DRAINAGE PLAN FOR LOT 27, BLOCK 15, TRACT 2, UNIT 1, N.A.A., (C-22/D36),
ENGINEER'S STAMP DATED AUGUST 6, 1993

SUPPLEMENTAL DRAINAGE CALCULATIONS
BALDWIN RESIDENCE

**BALDWIN RESIDENCE
GRADING & DRAINAGE PLAN**

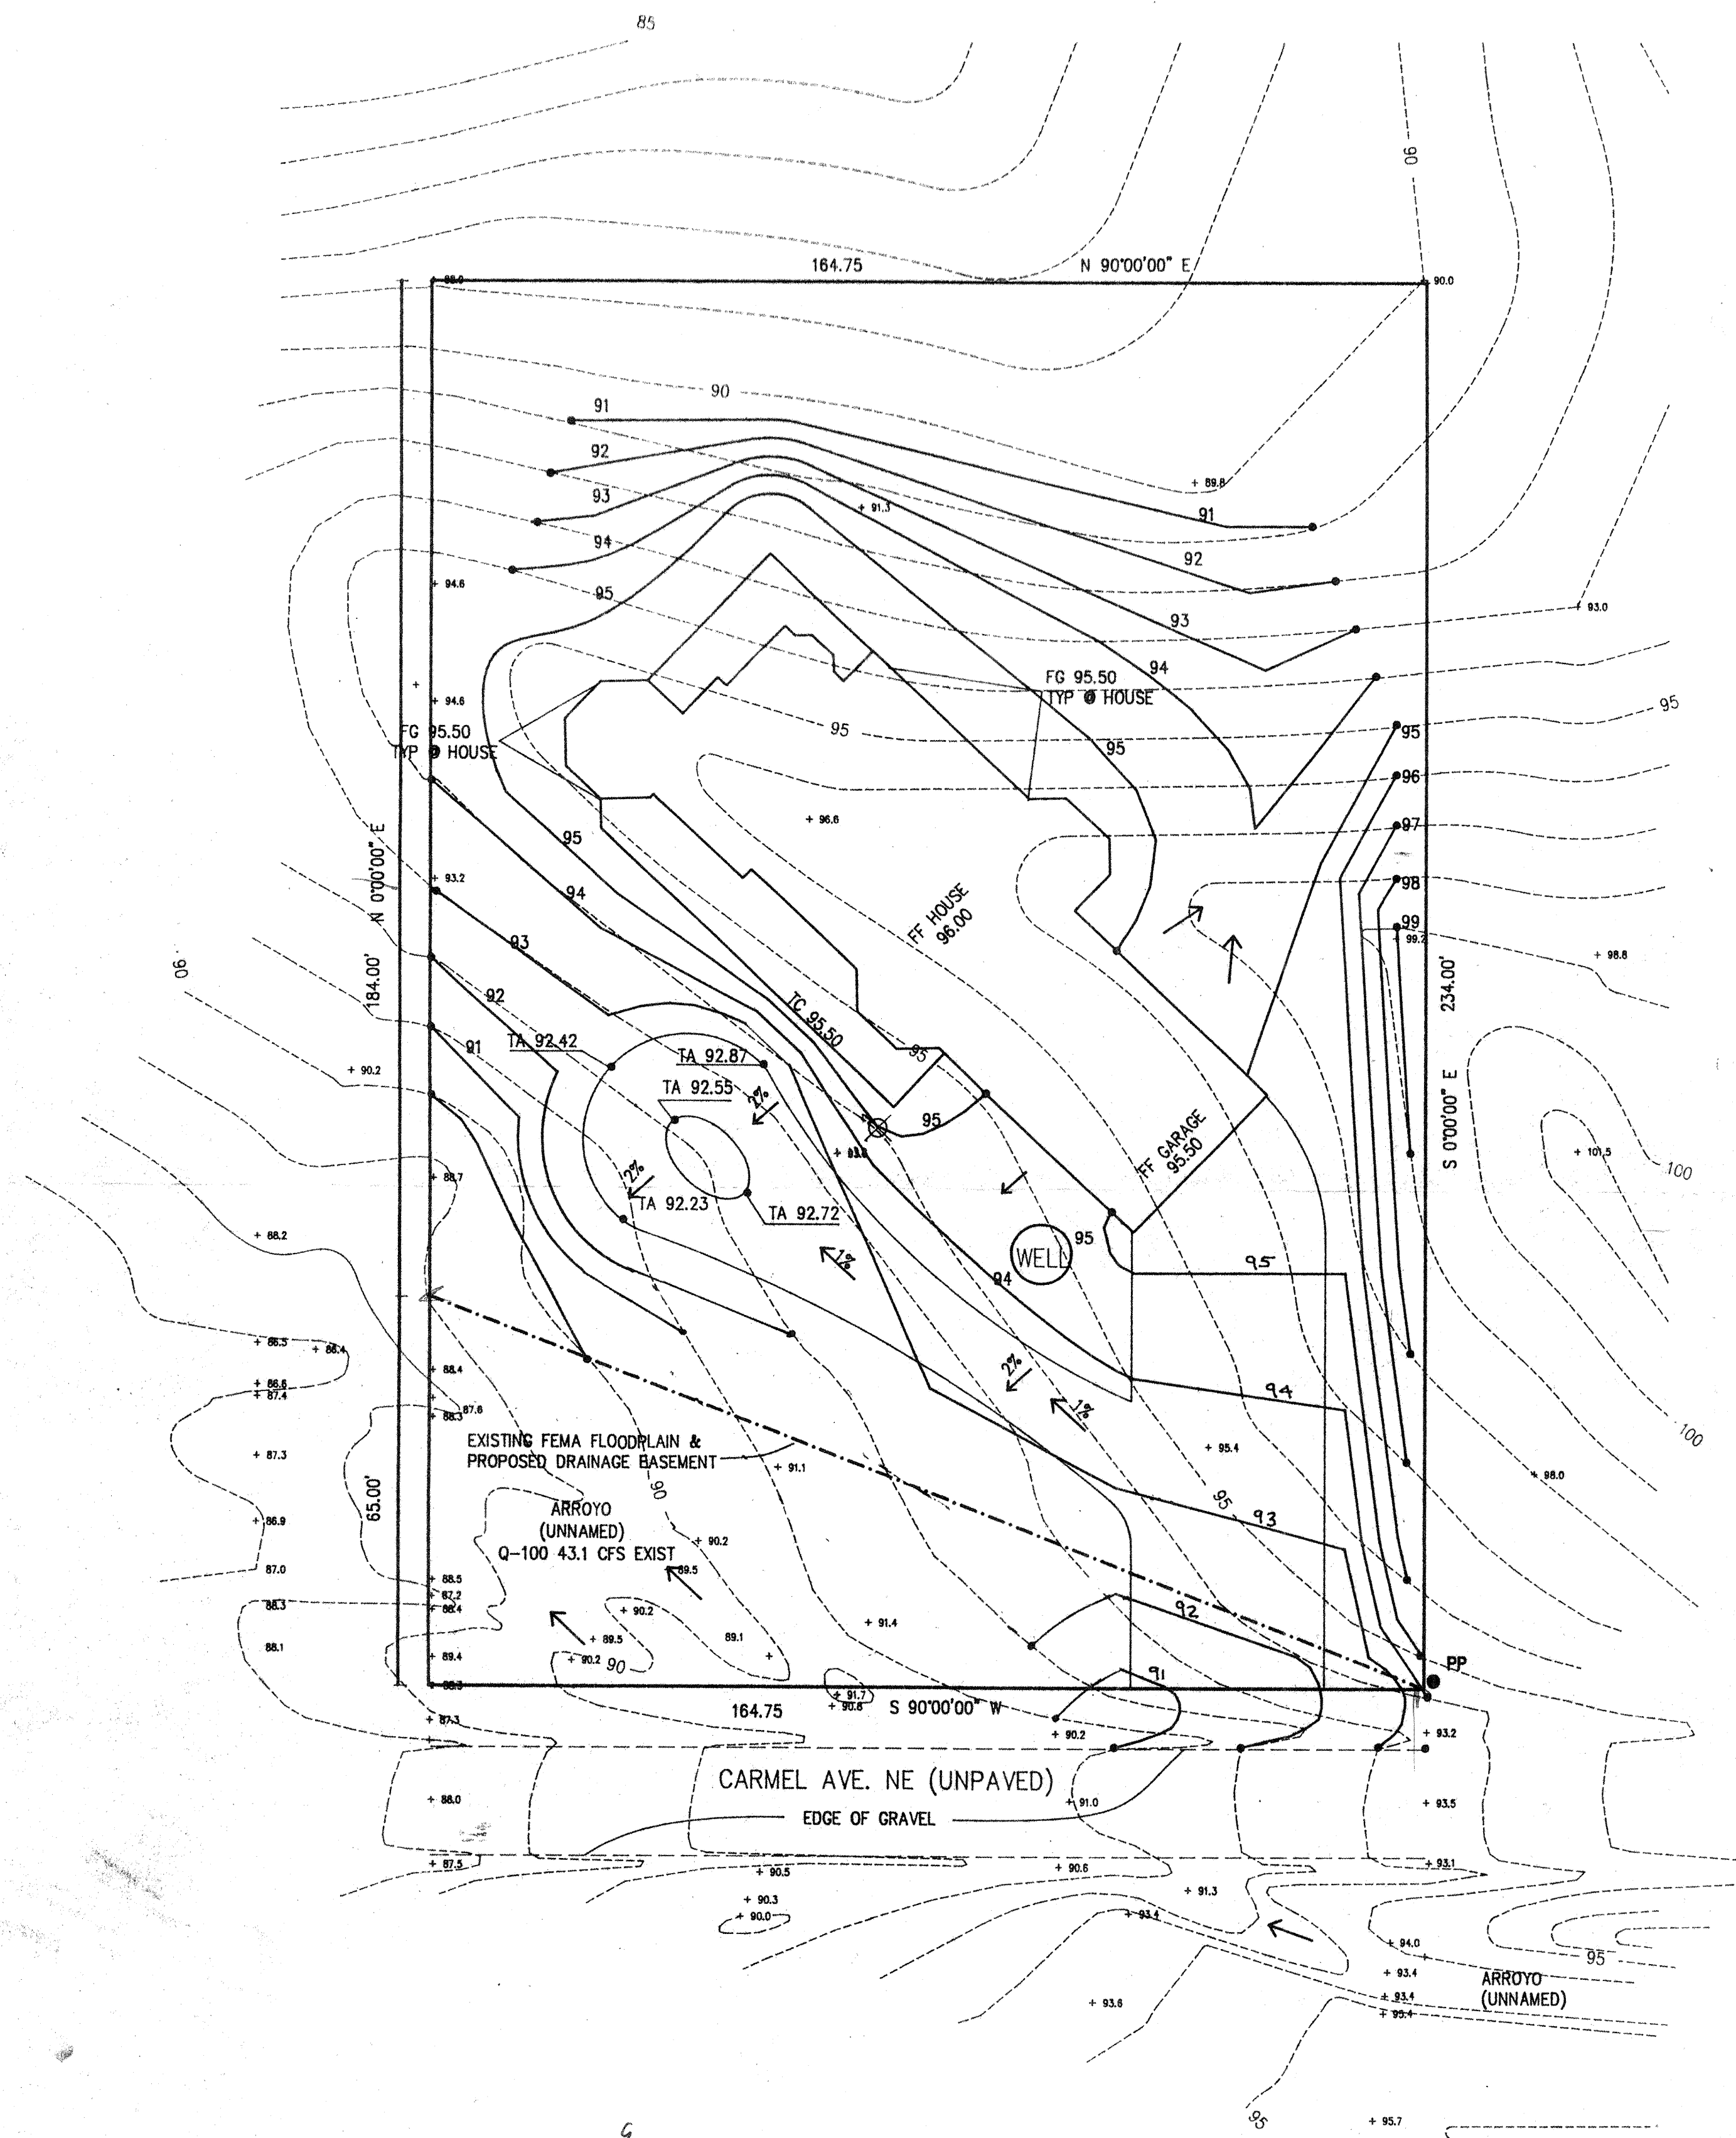
RESUBMITTAL NEEDS
* DEDICATION OF
EASEMENT PRIOR
TO RELEASE
OF B.P.
